**Subject: Independent Review of Direct Push Technology
Groundwater Sampling Work Plan
Lockheed Martin Tallevast Site (Former American Beryllium Company Site)
1600 Tallevast Road
Tallevast, Manatee County, Florida
E Sciences Project Number 1-1440-004**

E Sciences, Incorporated (E Sciences) is pleased to submit this letter outlining the results and opinions derived from our review of an April 12, 2021 document titled *Direct Push Technology Groundwater Sampling Work Plan – Lockheed Martin Tallevast Site* prepared by AECOM Technical Services, Inc. This document will be referenced herein as the “DPT Work Plan”.

**Figure 2 – 1,4-Dioxane Concentrations in Lower Surficial Aquifer System
(from Figure 13A from 2020 RASR) and
Proposed Sampling Location Identification (from Figure 2 from DPT Work Plan)**

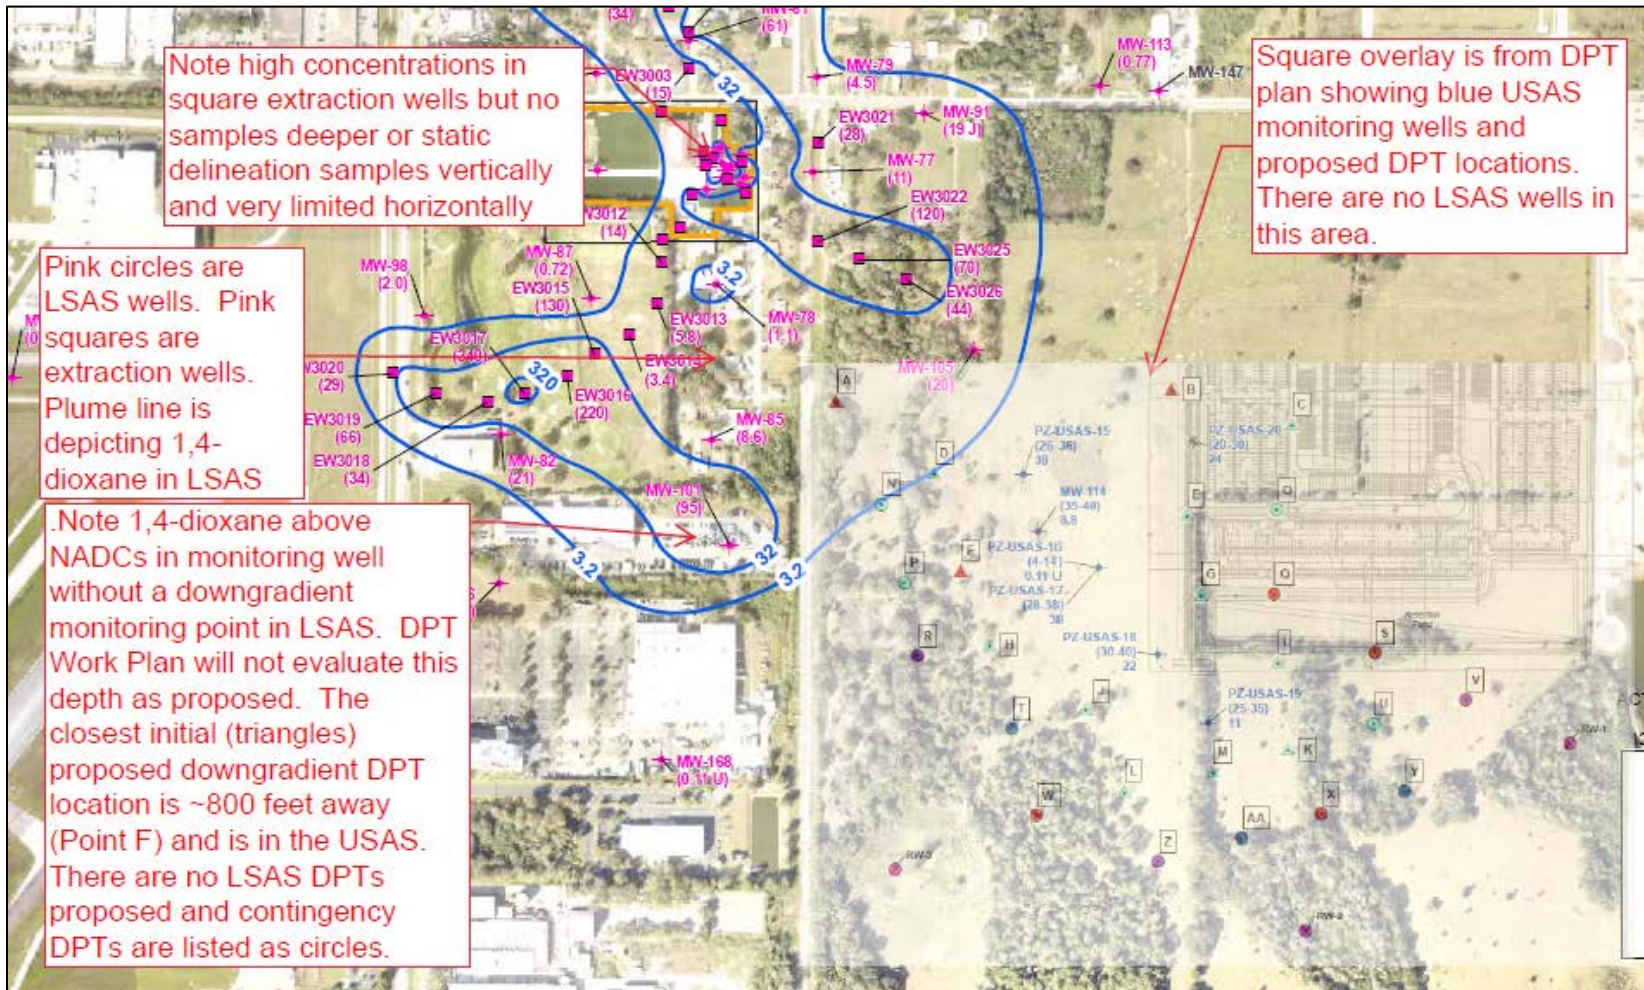
Figure 2 below shows an overlay of the proposed DPT locations relative to the LSAS plume contour. This graphic demonstrates that there are no horizontal delineation monitoring wells east or south of the leading edge well, MW-105, which is screened from 42 to 47 feet BGS. The graphic further indicates that there are no deeper downgradient monitoring wells. The DPT locations proposed are limited to a maximum depth of 40 feet BGS, which is actually less deep than some of the contaminated monitoring well screened intervals that have exhibited COCs exceedances. Due to the complexities associated with the solvent migration and hydrogeology, it would be reasonable to use this direct push planning opportunity to assess the deeper zone to ensure that the downgradient plume configuration is evaluated.

Recommendation: We recommend that continuous samples be collected from the direct push borings from the water table down to the hard streak at the bottom of the USAS. We also recommend that groundwater samples in the LSAS be collected in this area. If the hard streak prevents the use of direct push, an alternative technology should be used to delineate the horizontal and vertical extent of contamination in the deeper zones of the aquifer. Based upon data collected in the field from the USAS and LSAS sampling described here, additional sampling should proceed deeper into the AF Gravels and Salt and Pepper Sands as necessary to achieve vertical delineation. A thoughtful approach to assessing deeper impacts should be developed.

Figure 3 – 1,4-Dioxane Concentrations in the Arcadia Formation Gravels (Figure 14A from 2020 RASR)

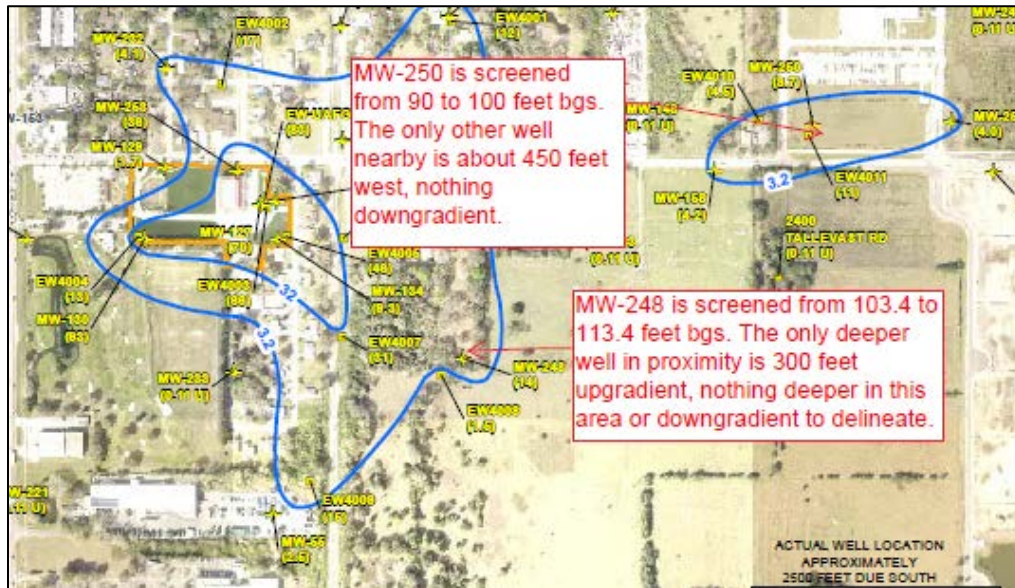
Figure 3 below shows Arcadia Formation (AF) wells that are screened down to 100 feet and show 1,4-dioxane above the GCTL. This demonstrates that there are un-delineated deeper impacts, well below the 40-foot proposed DPT intervals.

When taking a critical eye to these figures it can be observed that contamination is documented in AF Gravels monitoring wells screened at depths ranging in the ~90 to 115 foot BGS zone, but there are no downgradient AF Gravels monitoring wells delineating the horizontal extent of the plume. Further there are no deeper downgradient wells to delineate the vertical extent of the impacts. It is also of interest to see that groundwater contamination identified down to 172 feet BGS is not vertically delineated. There are no deeper downgradient monitoring wells to delineate the impacts identified at this depth.
